DOCKET NO. FHWA–2020-0001
NATIONAL STANDARDS FOR TRAFFIC CONTROL DEVICES; THE MANUAL ON UNIFORM TRAFFIC
CONTROL DEVICES FOR STREETS AND HIGHWAYS; REVISION

COMMENTS OF
THE ASSOCIATION OF AMERICAN RAILROADS
AND THE
AMERICAN SHORT LINE AND REGIONAL RAILROAD ASSOCIATION

**Comments on Docket No. FHWA-2020-0001 National Standards for Traffic Control Devices;
the *Manual on Uniform Traffic Control Devices for Streets and Highways*; Revision**

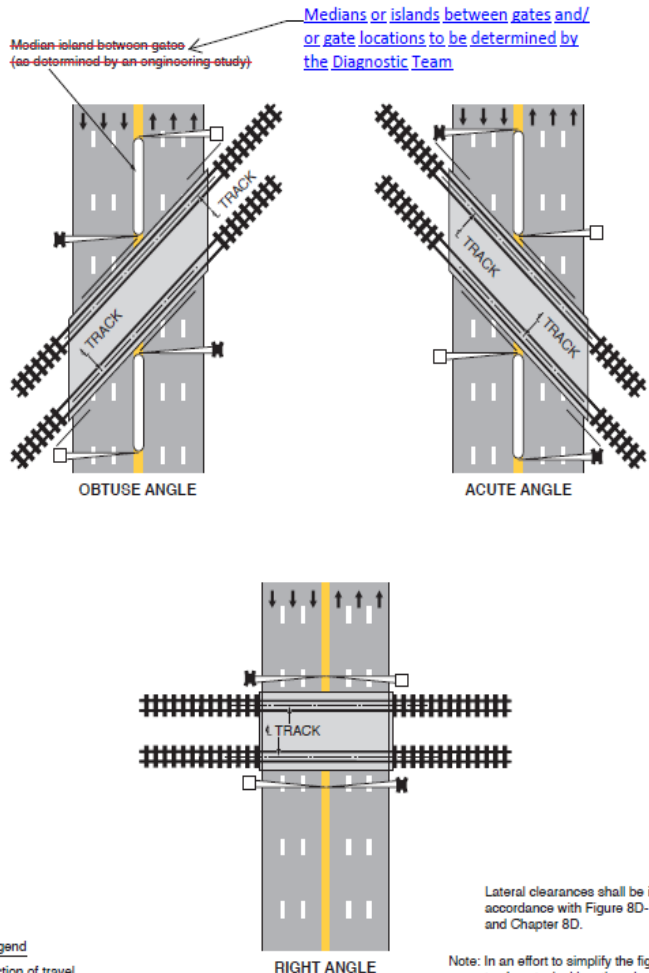
8C.06	NO	YES	N/A	<p>FHWA should revise the second sentence of the proposed Guidance statement in this section (at page 704, lines 38-40), to read as follows (AAR/ASLRRA-proposed additions are reflected by underlined language, with strikeouts reflecting proposed deletions):</p> <p>“If used, dynamic envelope pavement markings should be placed at a distance 6 feet from parallel to the nearest rail <u>in accordance with</u> unless the operating railroad company or LRT agency requirements standard advises otherwise”.</p> <p>This revision would delete reference to the six-foot limitation consistent with our comments on Section 8C.05 above, and would make this section consistent with proposed Section 8D.01.</p>

<p>Next, AAR/ASLRRA recommends FHWA delete Figure 8C-4 and its reference in this section (line 48 of page 704), because the markings are more clearly addressed in Figure 8C-3 and in Part C (Figure 8C-4 as proposed has the potential to cause confusion). Last, AAR/ASLRRA also recommends FHWA revise Figure 8C-3 to include an additional clarifying explanation regarding coordination between road authorities and the railroad or transit agency (to read as follows):</p> <p>“If crossing surface maintenance or approach roadway maintenance is required or performed which alters the markings, the removal of the markings should be coordinated between the road authority and the railroad or transit agency.”</p> <p>The proposed AAR/ASLRRA amendment to Figure 8C-3 is reflected in blue text in the figure below:</p>  <p>Note: Some pavement markings and other required traffic control devices have been omitted for clarity</p> <p>★ The distance between the rail and the dynamic envelope pavement marking should be equal to 6 feet unless otherwise advised by the operating railroad or light rail transit agency.</p> <p><u>If crossing surface maintenance or approach roadway maintenance is required or performed which alters the markings, the removal or replacement of the markings should be coordinated between the road authority and the railroad or transit agency.</u></p>

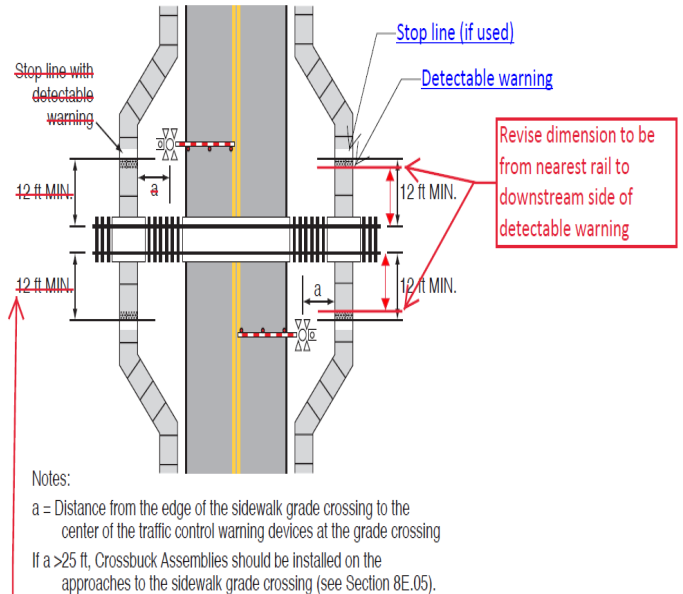
8D.05	NO	YES	N/A	<p>FHWA should revise the sentence beginning on line 34 of page 711 of the proposed Standard in this section to read as follows (AAR/ASLRRA-proposed additions are reflected by underlined language, with strikeouts reflecting proposed deletions):</p> <p>“If an Exit Gate system is present, the <u>queue exit gate</u> clearance time (see <u>AREMA Manual Part 3.3.10</u> Section 8D.10) shall be long enough to permit the exit gate arm to lower after a design vehicle of maximum length is clear of the minimum track clearance distance (see Section 8A.07).</p> <p>AAR/ASLRRA requests this change so the Standard is consistent with the American Railway Engineering and Maintenance-of-Way Association terms for exit gate clearance timing, and to amend the reference from Section 8D.10 to the applicable AREMA Communications & Signals Manual Part.</p> <p>Next, this section also references Figure 8D-2. AAR/ASLRRA recommends that for the “obtuse angle” drawing in Figure 8D-2, that</p>

<p>FHWA delete the proposed language accompanying that drawing and instead describe that:</p> <p>“Medians or islands between gates and/or gate locations to be determined by the Diagnostic Team.”</p> <p>AAR/ASLRRA recommends this change for purposes of consistency with Section 8D.01, and because a Diagnostic Team with benefit of railroad representation can more appropriately determine a median or island between gates. The proposed AAR/ASLRRA amendment to Figure 8D-2 is reflected in red text/strikethrough and blue text in the drawing below:</p>  <p>Median island between gates (as determined by an engineering study)</p> <p>Medians or islands between gates and/or gate locations to be determined by the Diagnostic Team</p> <p>OBTUSE ANGLE</p> <p>ACUTE ANGLE</p> <p>RIGHT ANGLE</p> <p>Legend</p> <ul style="list-style-type: none"> → Direction of travel ⌘ Entrance gate □ Exit gate <p>Lateral clearances shall be in accordance with Figure 8D-1 and Chapter 8D.</p> <p>Note: In an effort to simplify the figure to show typical location plans for flashing-light signals and four-quadrant gates, not all traffic control devices are shown on this figure.</p>

Figure 8E-2. Example of Placing Sidewalks on the Outside of the Gates at a Perpendicular Grade Crossing

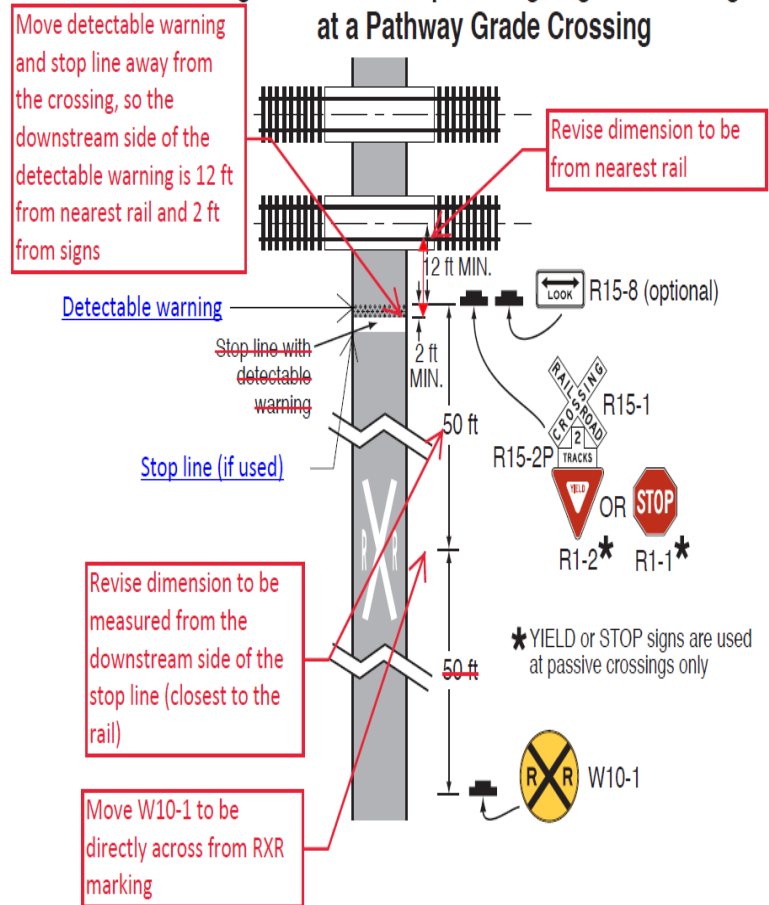
Next, this section references Figures 8E-2 and 8E-3. AAR/ASLRRA recommends those figures be revised as follows (proposed amendments in red text and blue underlined additional language). AAR/ASLRRA makes these requests so the figures are consistent with our comments on section 8E.04 further below (dimensioning in all Chapter 8E text, with figures revised to provide measurements from “nearest rail” for consistency purposes):

Remove duplicate dimensions on this side of the roadway

Revise dimension to be from nearest rail to downstream side of detectable warning

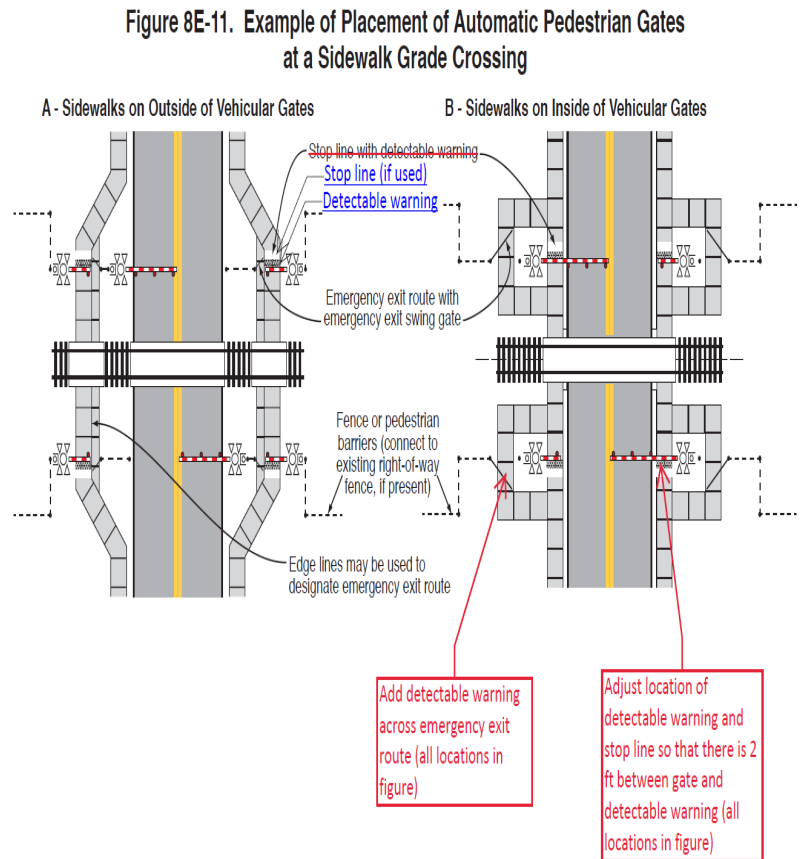
8E.06	YES	N/A	N/A	AAR/ASLRRA agrees with proposed Section 8E.06. However, this section references Figures 8E-7 and 8E-8. AAR/ASLRRA recommends a correction to the figure number from that published by FHWA for Figure 8E-7 (which was labeled Figure 8E-5. See discussion in Section 8E.04 above). AAR/ASLRRA also recommends amendments (AAR/ASLRRA's proposed additions reflected in red text/strikethrough and blue underlined additions) to Figure 8E-7 to show dimensions from the nearest rail and to show sign placement consistent with Section 8C.02:

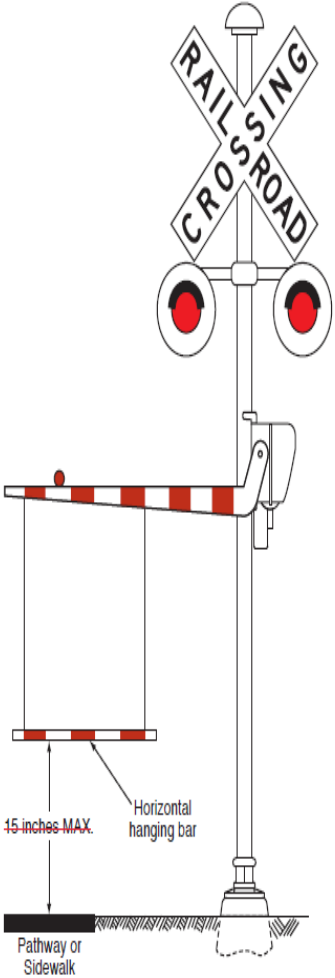
<p>Figure 8E-8. Example of Barriers at a Pedestrian-Only Pathway Grade Crossing</p> <p>Notes:</p> <ol style="list-style-type: none"> 1. The minimum distance from the <u>nearest rail</u> center of the nearest track to the barrier or fencing will be specified by the railroad company or LRT operating agency. 2. Maze fencing should be designed to fit pathway users.
Figure 8E-7	NO	YES	N/A	See the proposed amendments to Figure 8E-7 in the discussion of Section 8E.06 directly above.
Figure 8E-8	NO	YES	N/A	See the proposed amendments to Figure 8E-8 in the discussion of Section 8E.06 directly above.
8E.09	NO	YES	N/A	<p>AAR/ASLRRA recommends revision to the proposed Guidance statement on page 737 (lines 43-45). AAR/ASLRRA recommends deletion of the reference to the 15-inch height in the FHWA proposal, and replacement with reference to the determination of the Diagnostic Team. The railroads recommend such because research has been conducted regarding the horizontal bar at various heights, and the Railroad/Light Rail Transit Technical Committee supports a Diagnostic Team making the determination regarding the appropriate height. The railroads' proposed revisions to the Guidance statement are as follows ((proposed AAR/ASLRRA additions underlined, strikethrough for proposed deletions):</p> <p>"If a horizontal hanging bar is attached to an automatic pedestrian gate, the height of the horizontal hanging bar when in the down position should be <u>a maximum of 15 inches above the pathway or sidewalk</u> determined by the Diagnostic Team."</p> <p>Next, AAR/ASLRRA proposes revisions to Figures 8E-11 and 8E-14 that are referenced in this section. FHWA should revise Figure 8E-11 to add detectable warning across the emergency exit route and to locate detectable warning and stop lines consistent with Section 8E.04. AAR/ASLRRA's proposed amendments to Figure 8E-11 are</p>

reflected in red text/strikethrough and blue underlined additions in the figure below:
